Livestock Plaza/Sheep Barn

Addendum Issue Date: 8/8/24

The following changes, revisions, or clarifications shall be made to the drawing documents.:

SHEET: A6.1

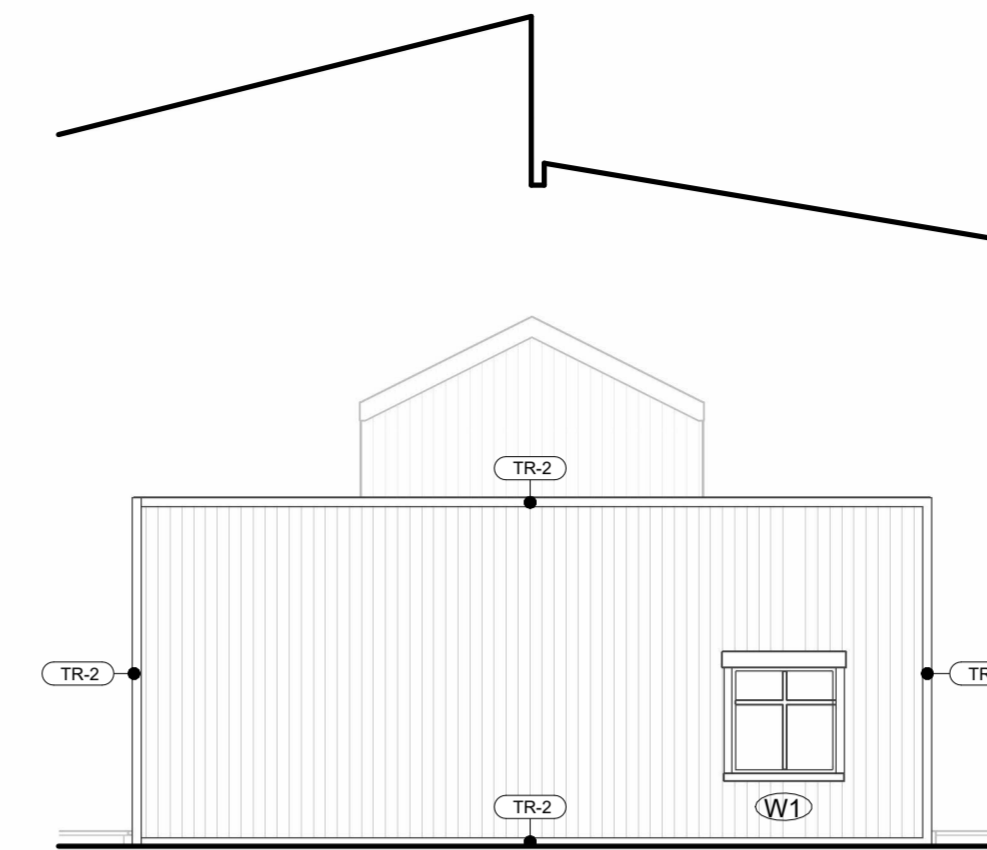
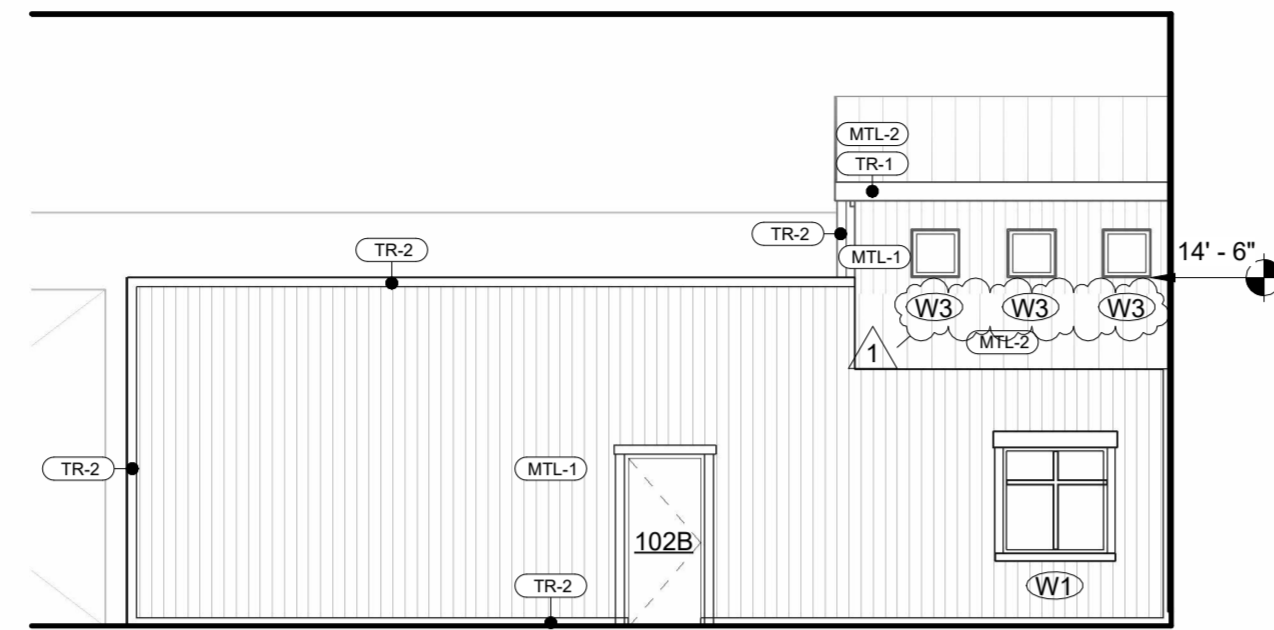
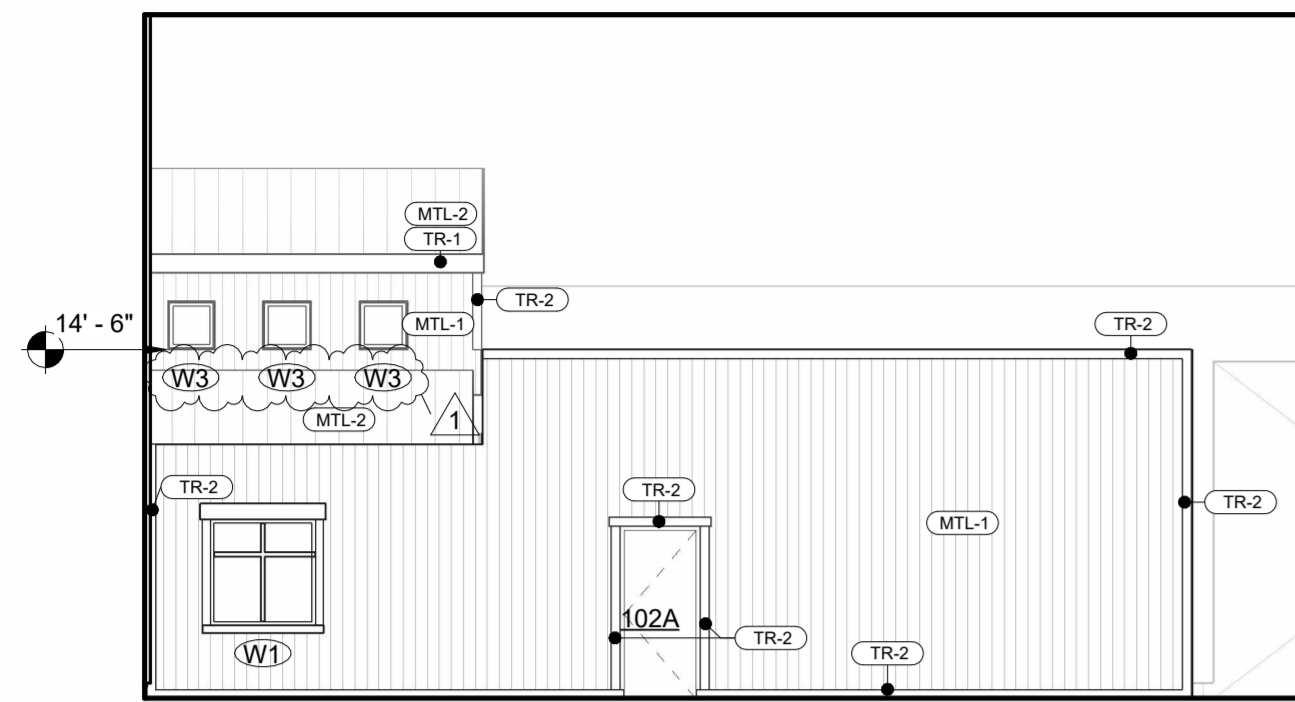
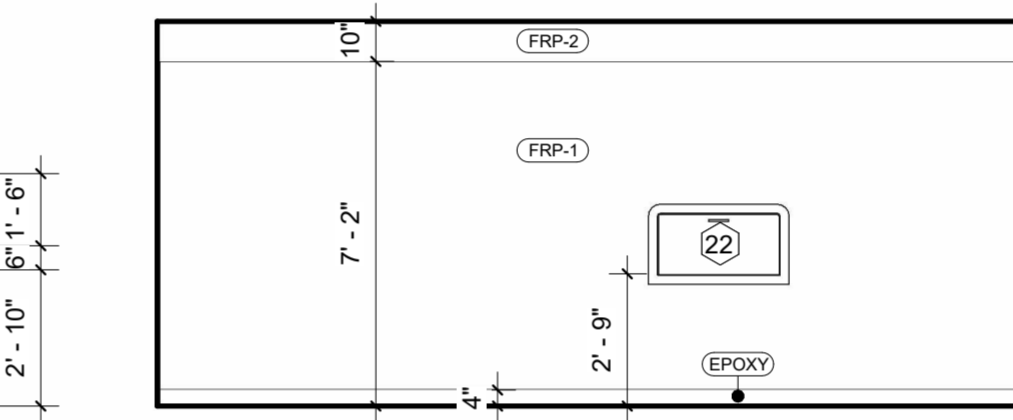
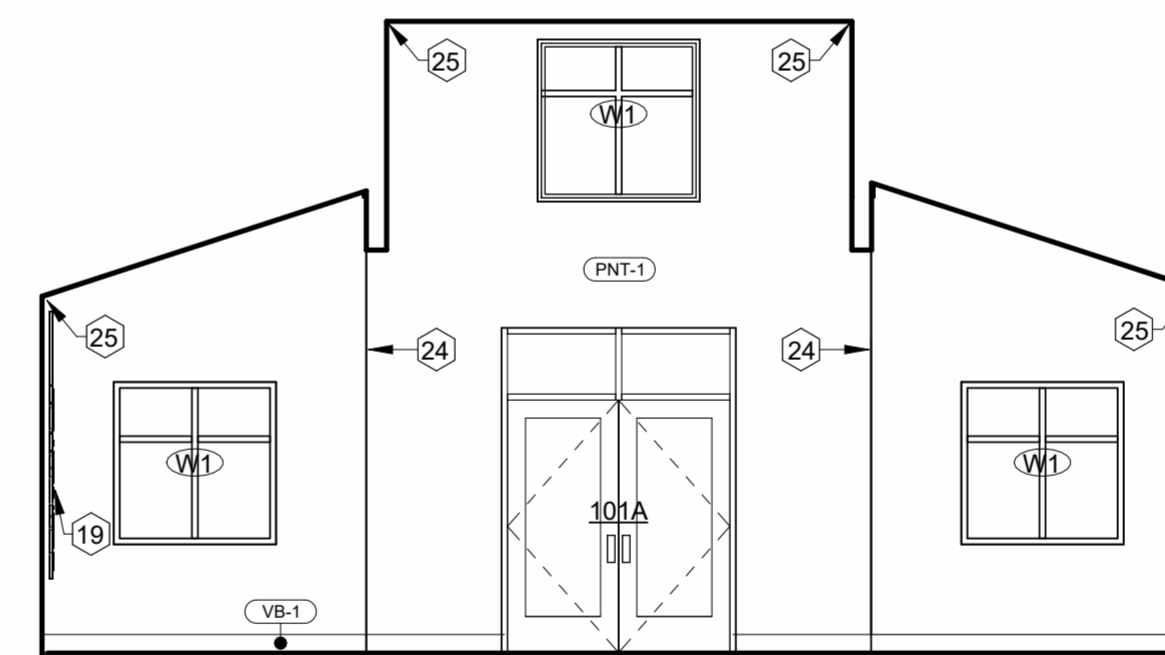
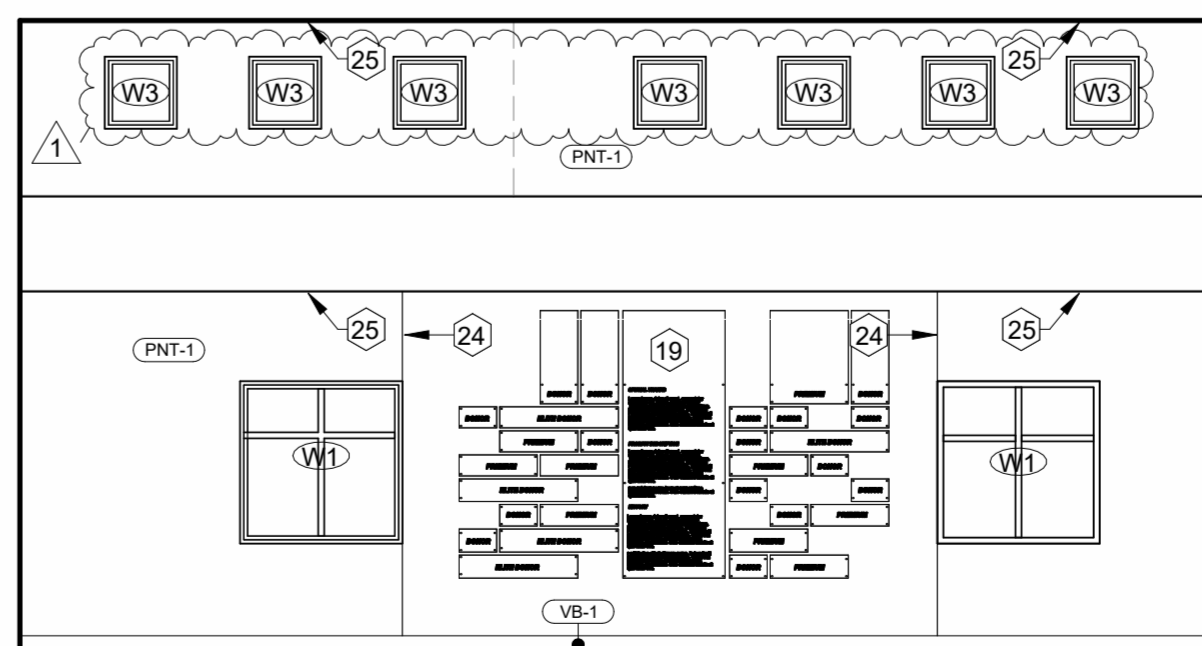
Sheet A6.1 - Interior Elevations:

Material tags for the trim have been revised.

Keynote 19 is revised.

A7.1

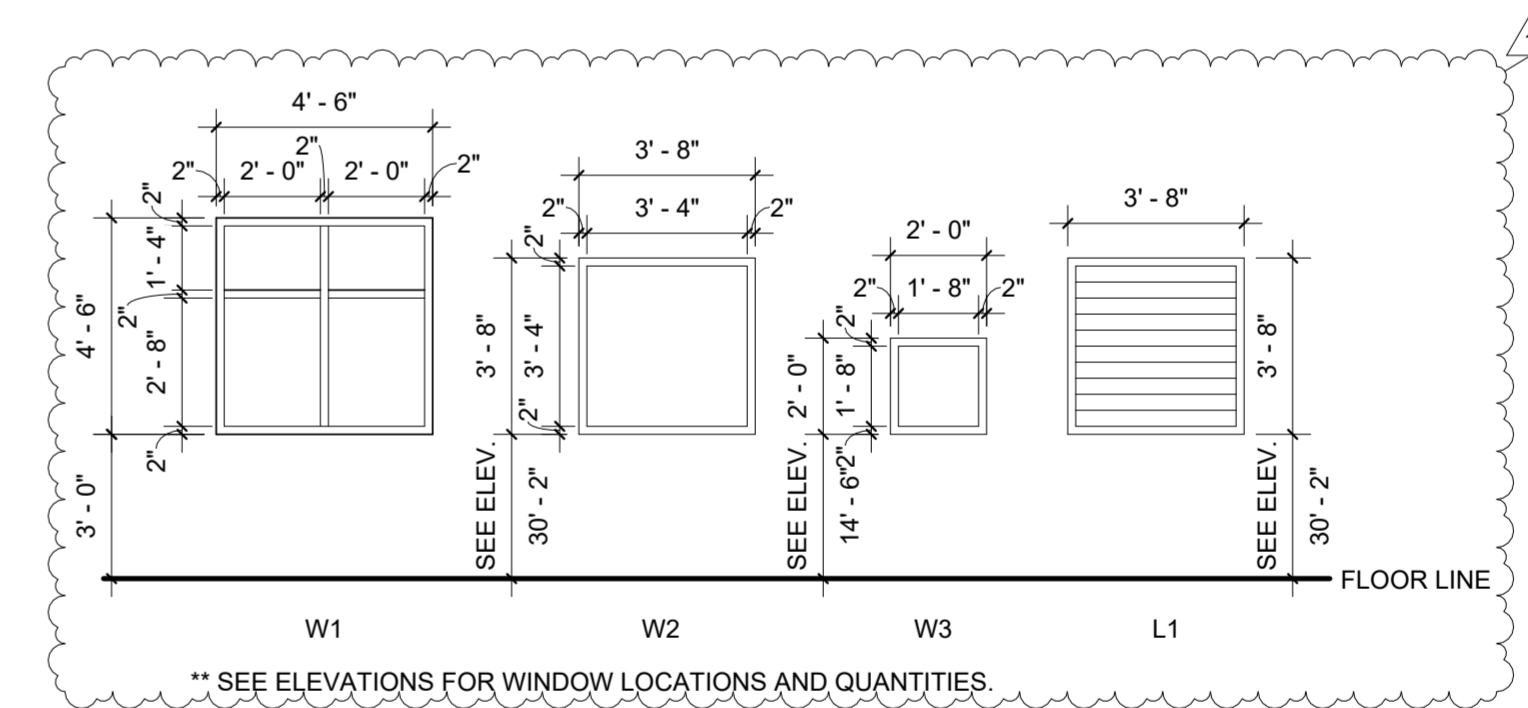
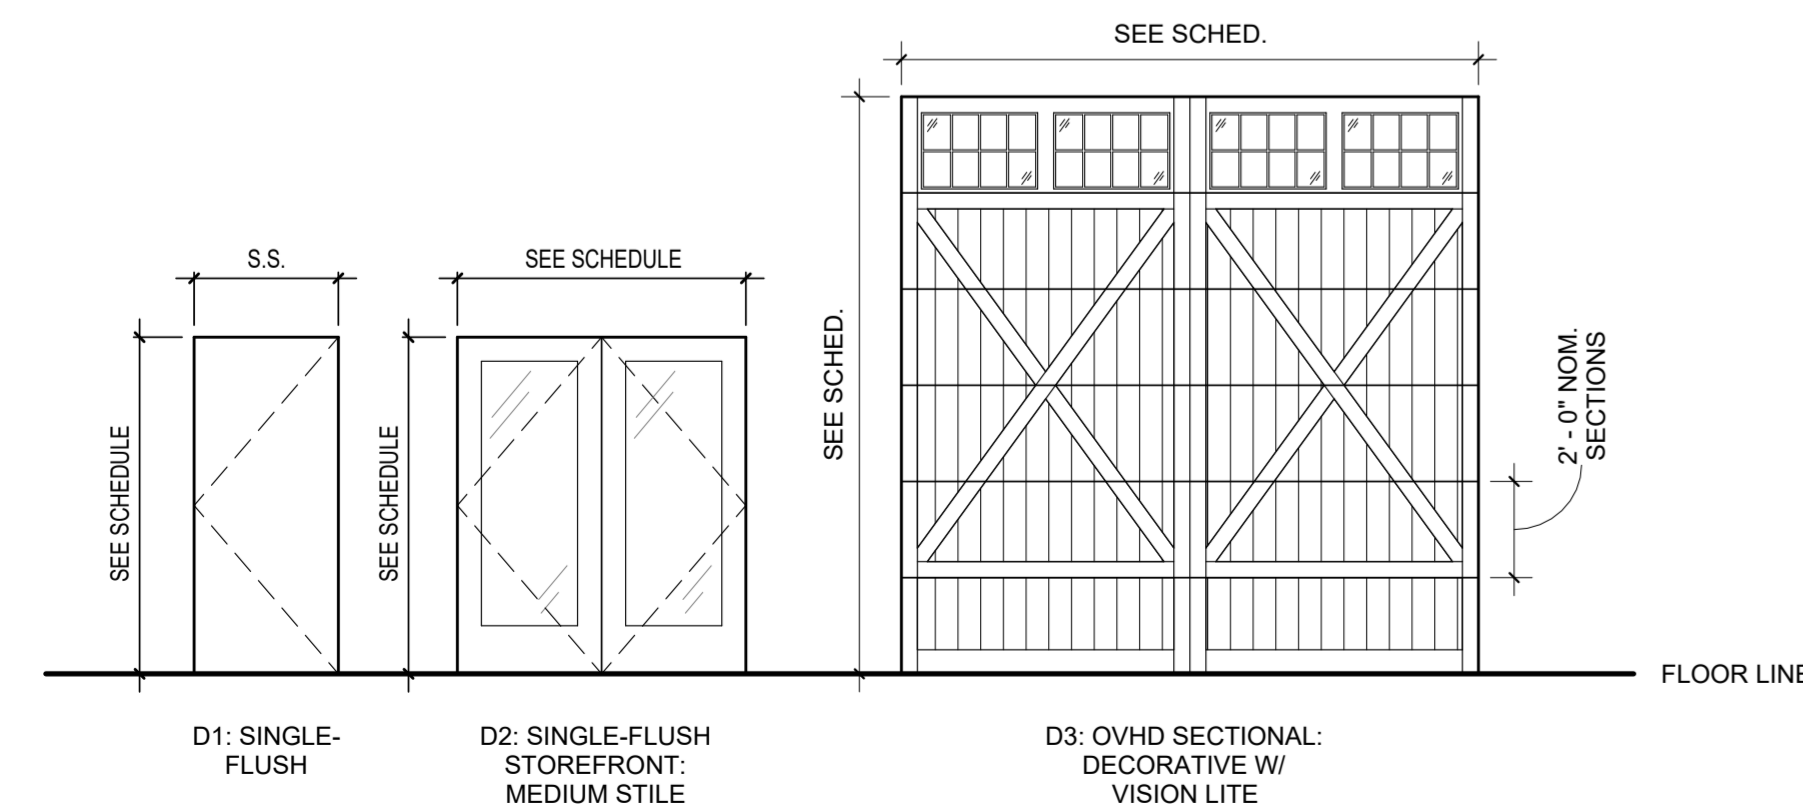
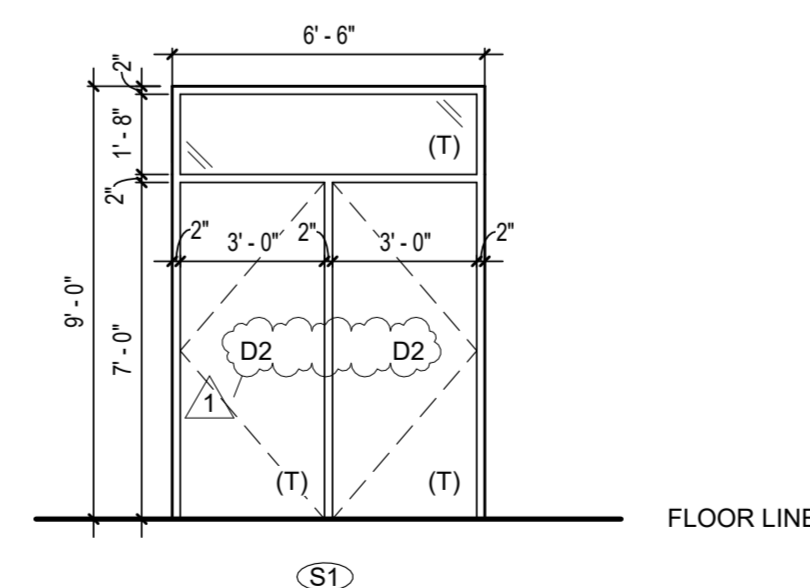
Sheet A7.1 – Schedules & Door Elevations:

LVT-1 flooring revised.
